AVN-20211202 Problematic MEMS Oscillator

Company	Trenz Electronic GmbH
AVN Number	AVN-20211202
Title	Problematic MEMS Oscillator
Subject	Information and remedy concerning problematic MEMS Oscillator
Issue Date	2021-12-09

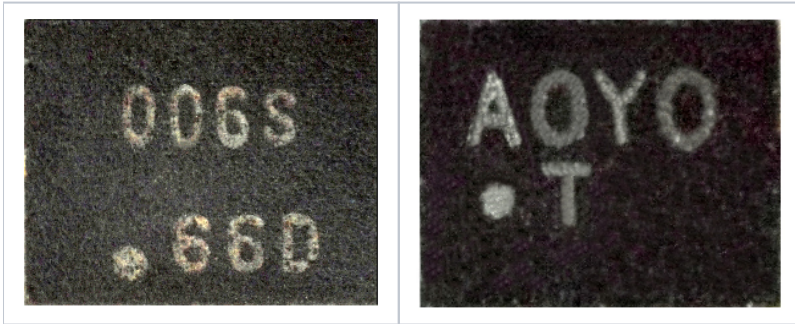
Due to component shortage from June to August 2021 some Trenz Electronic products were assembled with datasheet compatible DSC6111MI2A-025.0000 instead of SiT8008BI-73-18S-25.000000E. Although there is no evidence for any performance issues from the datasheets at least one batch of DSC6111MI2A-025.0000 has been identified to be root of issues in specific applications.

1. Ethernet communication with online available standard reference design is unreliably:
 - a. Standard ping test in separated environment results in package loss of up to 10% or
 - b. unexpected link up/down switches.
2. MGT communication fails, known to work designs showed no link.

If a Trenz Product shows one of the issues described above and the assembled MEMS oscillator is identified as DSC6111MI2A-025.0000 (see Method of Identification) please contact Trenz Electronic (see Contact Information). Please send the serial number of the affected product and choose one of the possible solutions below:

1. Trenz Electronic opens a RMA and the affected MEMS is replaced at Trenz Electronic.
2. Trenz Electronic sends a SiT8008BI-73-18S-25.000000E for substitution to the customer.
